Agenda
Village of Arlington Heights
Design Commission
Community Room, 3rd Floor

Arlington Heights Village Hall
33 S. Arlington Heights Road
Arlington Heights, IL 60005
June 26, 2018
6:30 PM

MINUTES OF
THE VILLAGE OF ARLINGTON HEIGHTS
DESIGN COMMISSION MEETING
HELD AT THE ARLINGTON HEIGHTS MUNICIPAL BUILDING
33 S. ARLINGTON HEIGHTS RD.
JUNE 12, 2018

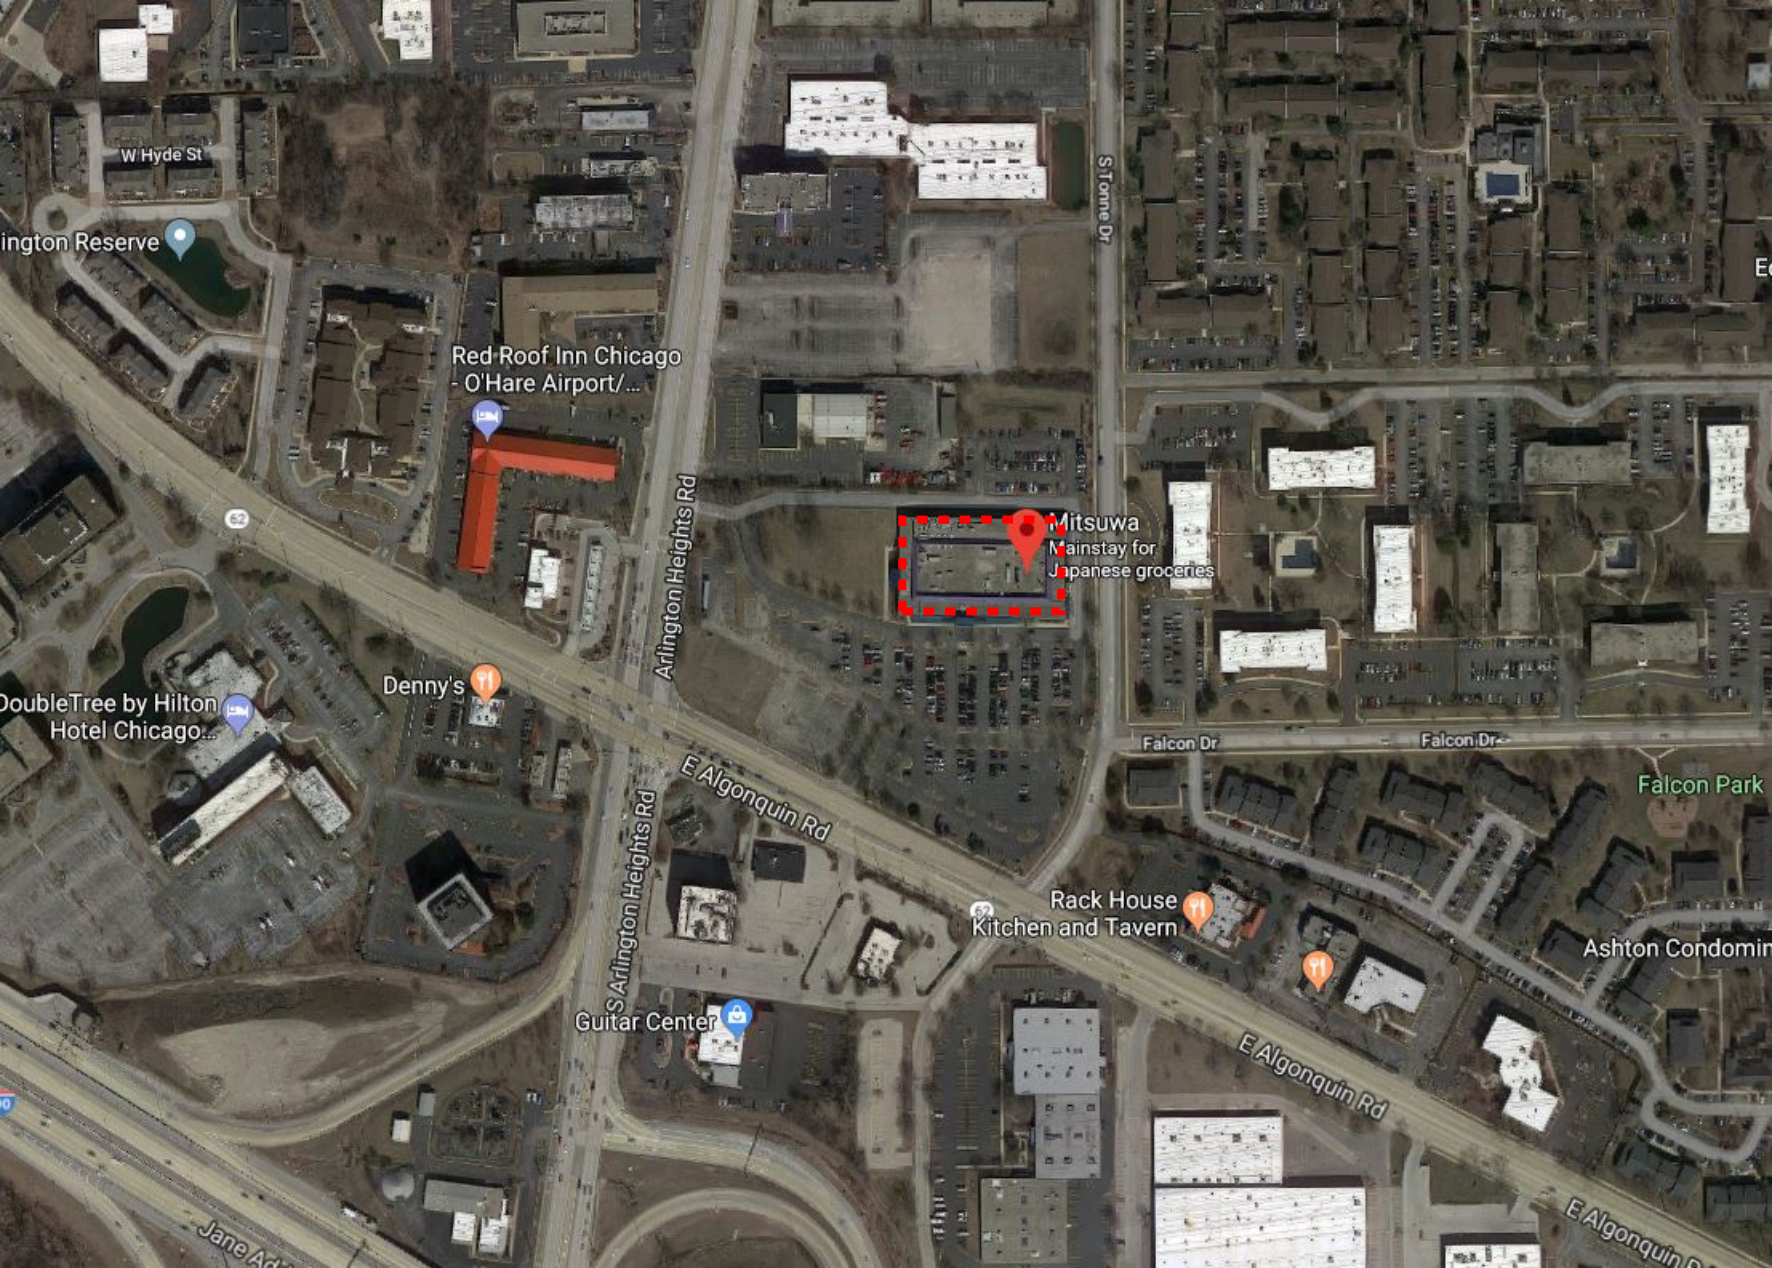
It is recommended that the Design Commission either **deny or require revisions and re-review** the proposed exterior façade changes to *Mitsuwa* located at 100 E. Algonquin Road. This recommendation is based on the plans received on 6/5/18, Design Commission recommendations, compliance with all applicable Federal, State, and Village codes regulations and policies, the issuance of all required permits, and the following conditions:

1. A recommendation to keep the existing blue clay tile roofing.
2. A recommendation to freshly paint the red columns, beams, and downspouts using the original red color.
